ADDENDUM NUMBER TWO

RFQ # 7457889

TITLE: TOILET ROOM UPGRADES - DOA

PROJECT: Toilet Room Upgrades at the Rhode Island Department of Transportation- Operations Center,
Two Capitol Hill, Providence, RI

EXISTING/NEW MEN'S TOILET ROOM

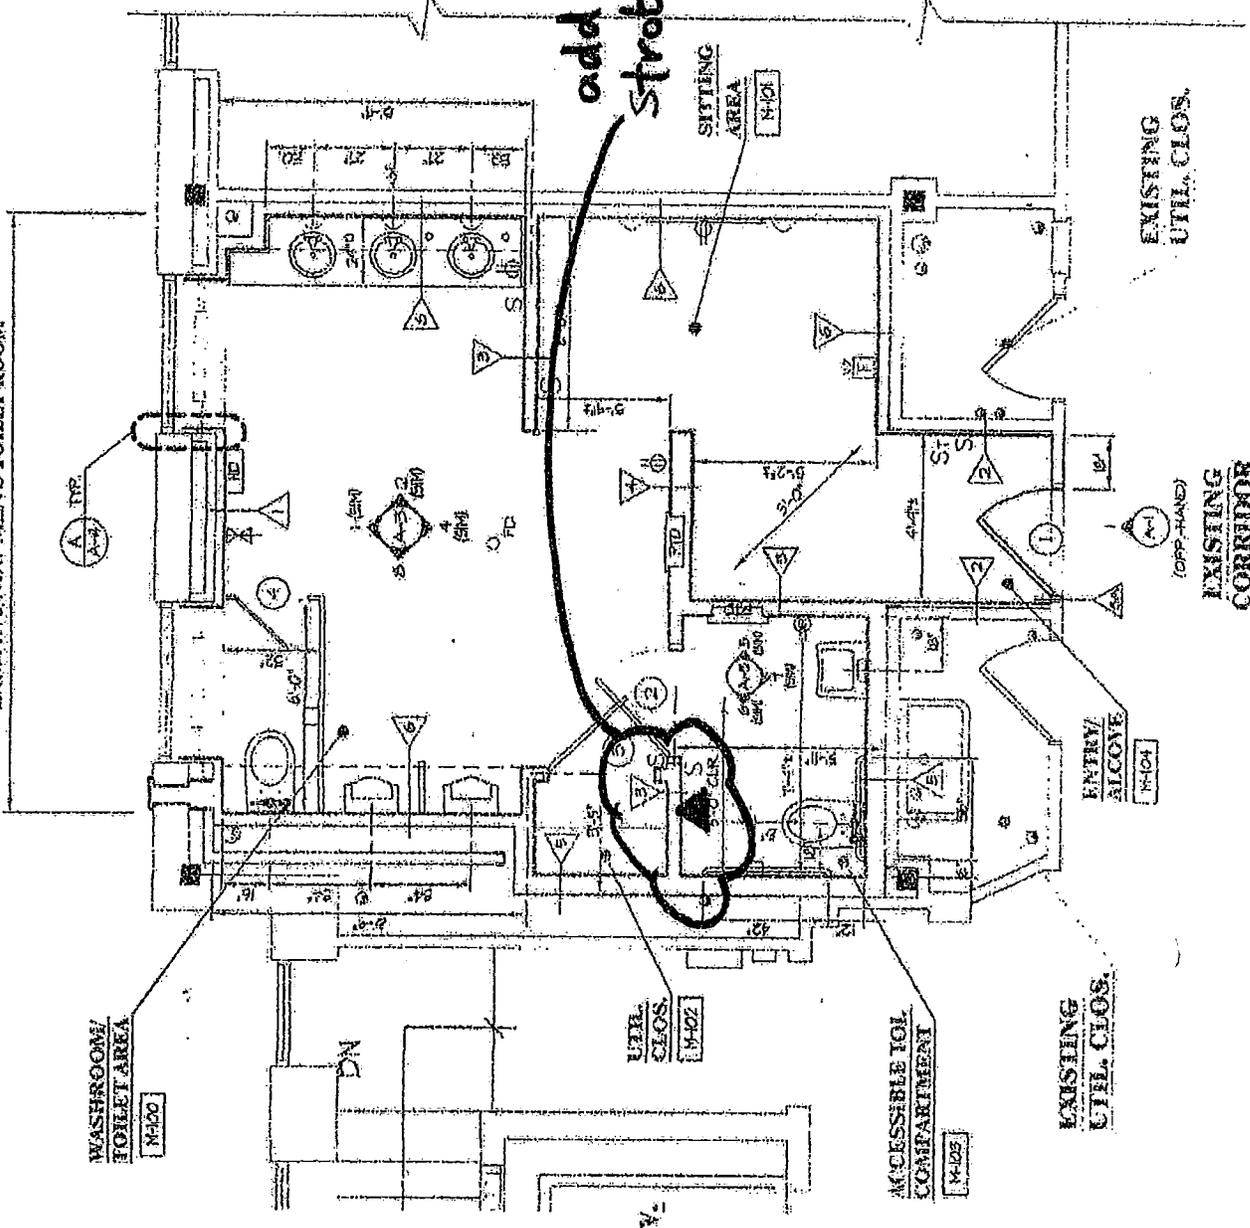
7. One (1) fire alarm strobe (without horn) shall be provided in each accessible toilet stall within the Men's and Women's Primary Toilet Rooms {six (6) total}, installed 80" above the finished floor, and in accordance with NFPA 72 and the 2008 Rhode Island Uniform Fire Code. Refer to the attached sketch.

add fire alarm
Strobe (w/o horn)

Fig. 604.5.1
Side Wall Grab Bar for Water Closet

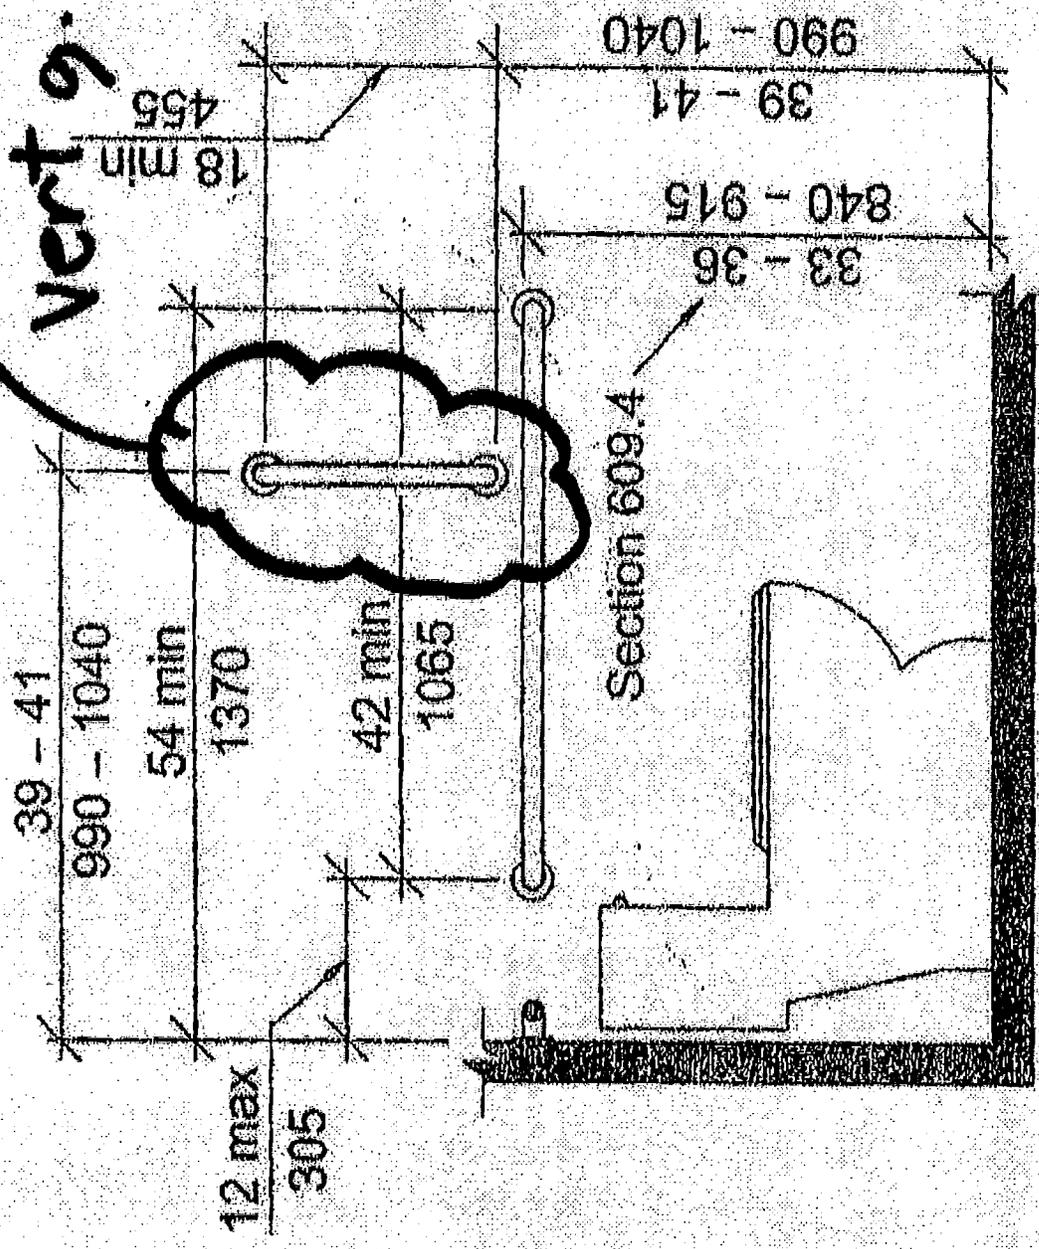
8. One (1) 18" additional grab bar (vertical) shall be provided to each accessible toilet stall {eight (8) total}, installed in accordance with the attached sketch.

additional
vert 9-b.
